UNITED STATES PATENT AND TRADEMARK OFFICE

APPLICATION NO.	FILING DATE	FIRST NAMED INVENTOR	ATTORNEY DOCKET NO.	CONFIRMATION NO.
09/882,164	06/15/2001	Steponas Dziugys	67064	9384

Office Action Summary	Application No. 09/882,164	Applicant(s) DZIUGYS ET AL.	
	Examiner Douglas A. Hess	Art Unit 3651

[54] **SINGLE DRUM MATERIAL ORIENTATION APPARATUS AND METHOD**

FIG. 1

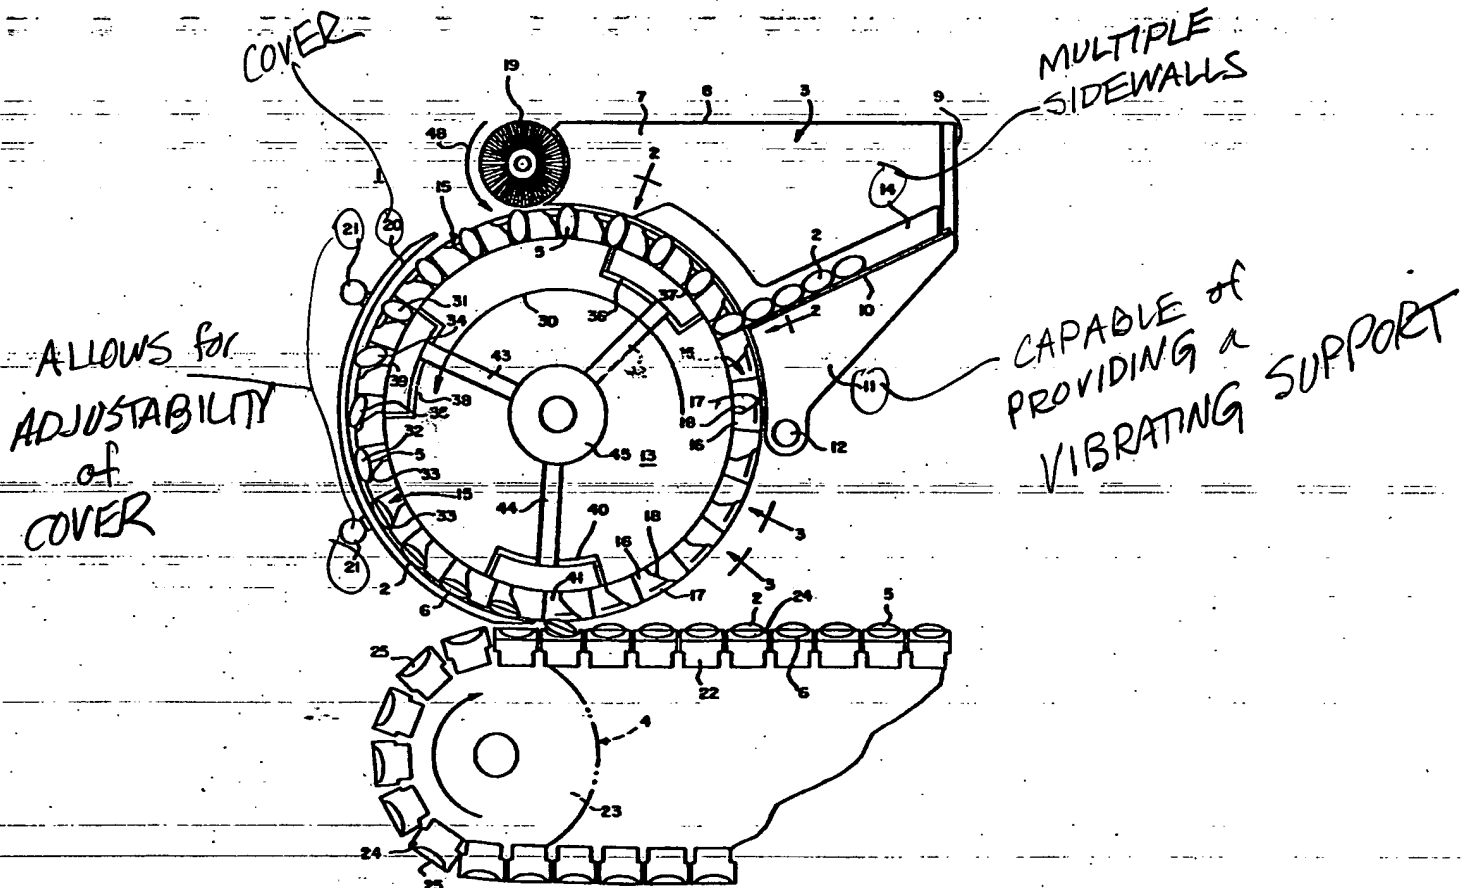
8. Claims 4-12 and 16 are rejected under 35 U.S.C. 103(a) as being unpatentable over Boyce et al. in view of Ackley USP 4,308,942.

Boyce et al. Teaches the claimed invention as outlined above. Boyce fails to disclose the adjustable cover, the claimed sidewalls, and the vibrating support. Ackley teaches similar apparatus as Boyce, Ackley’s device (see attached marked up cover sheet of Ackley) does disclose sidewalls 14, a support 11 capable of providing a vibration, and an adjustable connection 21, 21 for his cover 20.
